From: A. Amr
To: C. Jackson
Date: 3/28/96
Subject: Palo Verde USQ

RESPONSE TO COMMENTS ON CALC. 13- NC- ZY-205

Per our telephone conversation on 2/28/1996, the following is provided to show that assumptions in calculation 13-NC-ZY-205 are conservative and to clarify how equations were derived:

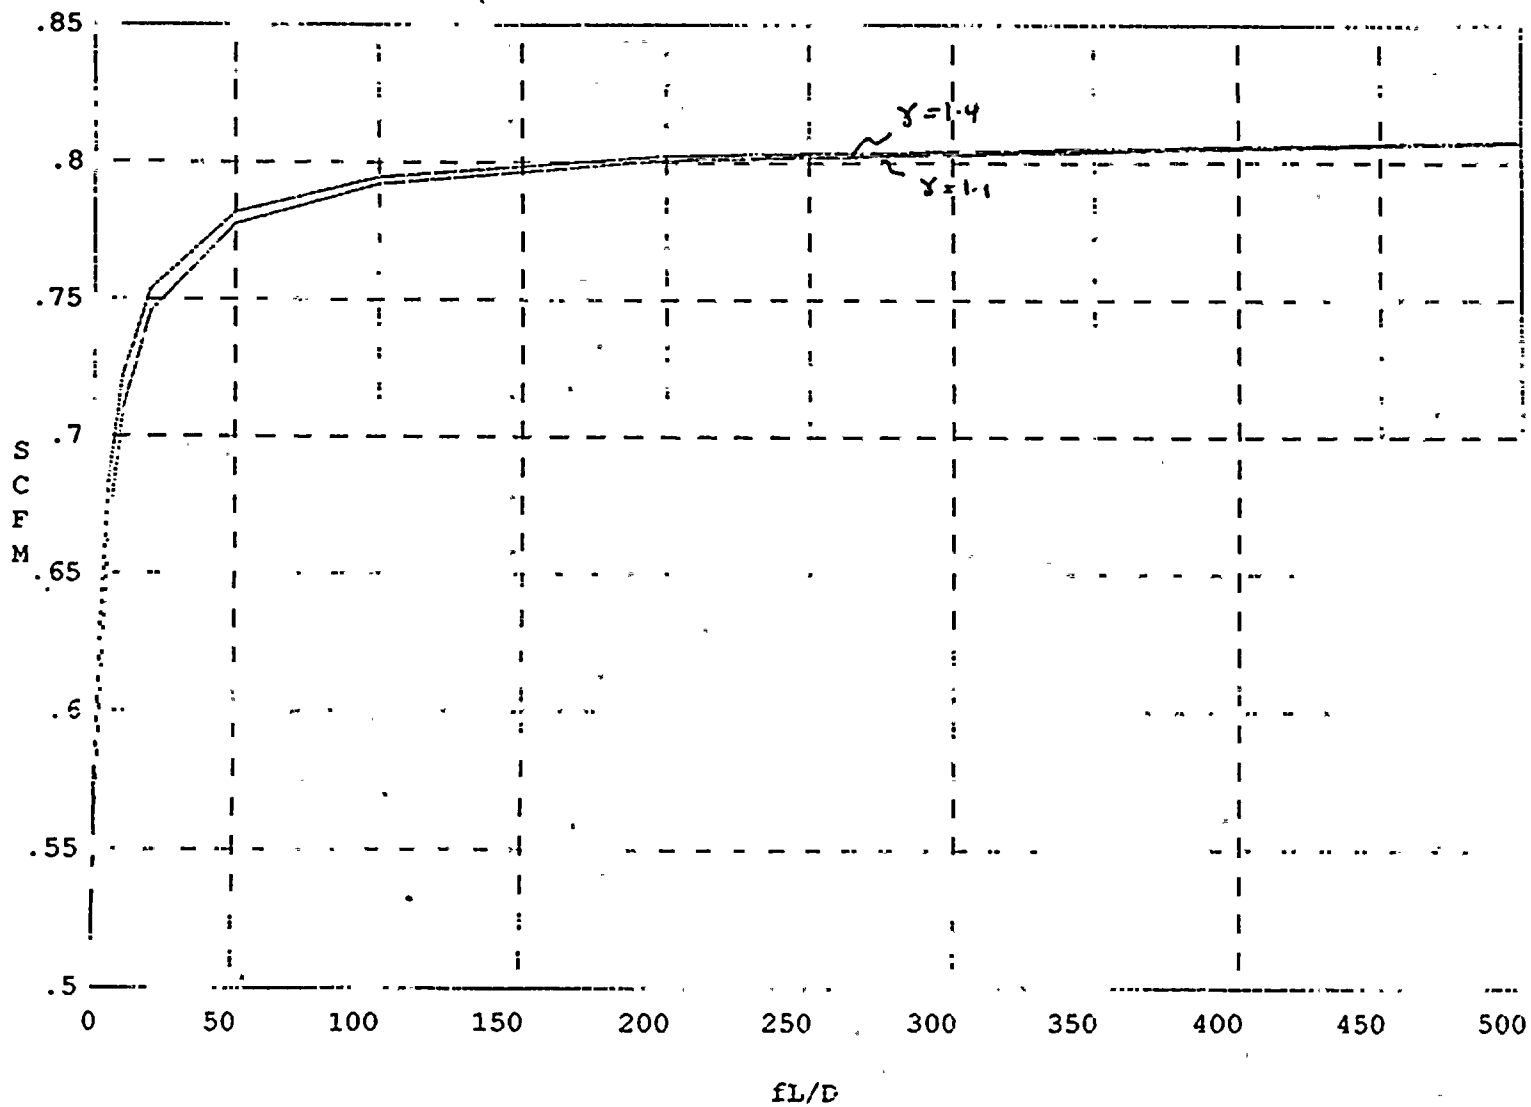
6- USING A LOSS COEFFICIENT OF 200

As discussed previously the increase of flow with loss coefficient is logarithmic as seen in attached Figure. Extrapolating the curve linearly to the SCFM value of 0.9 this corresponds to a loss coefficient of 1700. In essence the assumption in calculation is that the crack loss coefficient used is 1700. In the absence of an agreement on crack characteristic this assumption is acceptable based on engineering judgment.

for SCFM = 0.9
FL/D = 1700
